PRODUCT / PROCESS CHANGE NOTIFICATION

1. PCN basic data	
1.1 Company	STMicroelectronics International N.V
1.2 PCN No.	EMBEDDED PROCESSING/26/15941
1.3 Title of PCN	ST Crolles (France) STM32H74x & STM32H75x – product enhancements
1.4 Product Category	STM32H742x, STM32H743x, STM32H753x, STM32H750x, STM32H745x, STM32H755x, STM32H747x and STM32H757x
1.5 Issue date	2026-11-06

1. PCN basic data	
1.1 Company	STMicroelectronics International N.V
1.2 PCN No.	EMBEDDED PROCESSING/26/16580
1.3 Title of PCN	SAMSUNG Foundry (Korea) STM32H74x & STM32H75x - product enhancements
1.4 Product Category	STM32H742x, STM32H743x, STM32H753x, STM32H750x, STM32H745x, STM32H755x, STM32H747x and STM32H757x
1.5 Issue date	2026-11-09

1. PCN basic data	
1.1 Company	STMicroelectronics International N.V
1.2 PCN No.	EMBEDDED PROCESSING/26/16579
1.3 Title of PCN	HHGrace (China) STM32H74x & STM32H75x - product enhancements
1.4 Product Category	STM32H742x, STM32H743x, STM32H753x, STM32H750x, STM32H745x, STM32H755x, STM32H747x and STM32H757x
1.5 Issue date	2026-11-06

The standard marking fields example for **UFBGA 10X10 176+25** package

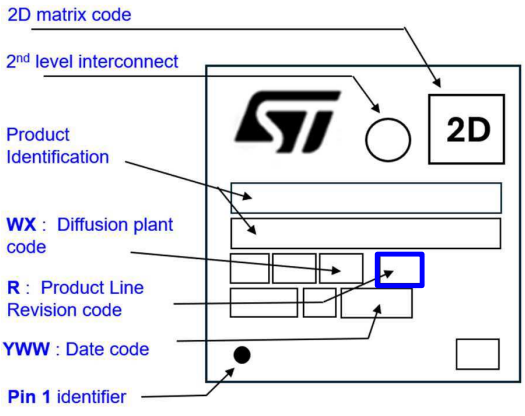
6. Marking of parts / traceability of change	
6.1 Description	Traceability ensured by ST internal tools. Die revision visible on top marking is updated : - Crolles 300: revision from "V" to "T"

How can the change be seen?

ST Crolles 12" (France)	
		old	new
WX	***Diffusion Plant code***	***VQ***	
R	***Revision code***	*V*	***T***

The standard marking fields example for **UFBGA 10X10 176+25** package

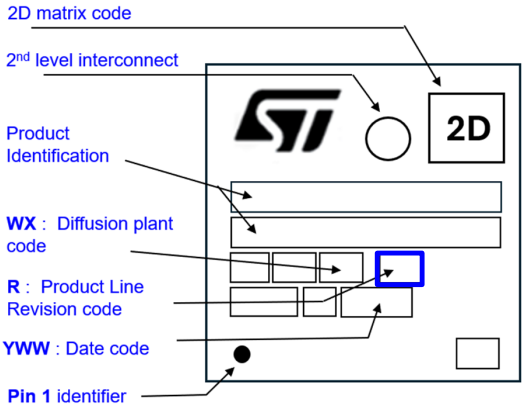
6. Marking of parts / traceability of change	
6.1 Description	Traceability ensured by ST internal tools. Die revision visible on top marking is updated : - Samsung Foundry : revision from "1" to "6"

How can the change be seen?

SAMSUNG Foundry (South Korea)	
		old	new
WX	***Diffusion Plant code***	***LM***	
R	***Revision code***	*1*	*6*

The standard marking fields example for **UFBGA 10X10 176+25** package

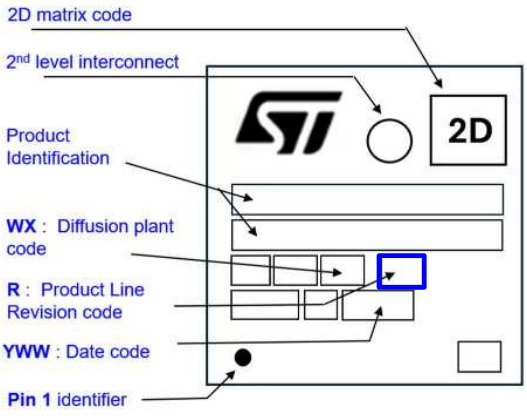
6. Marking of parts / traceability of change	
6.1 Description	Traceability ensured by ST internal tools. Die revision visible on top marking is updated : - HHGrace fab7: revision from "2" to "4" - HHGrace fab9: revision from "3" to "5"

How can the change be seen?

HHGrace Wuxi (China)			
		old		new	
		Fab7	Fab9	Fab7	Fab9
WX	***Diffusion Plant code***	**Y5**	**2E**	**Y5**	**2E**
R	***Revision code***	2	3	**4**	**5**
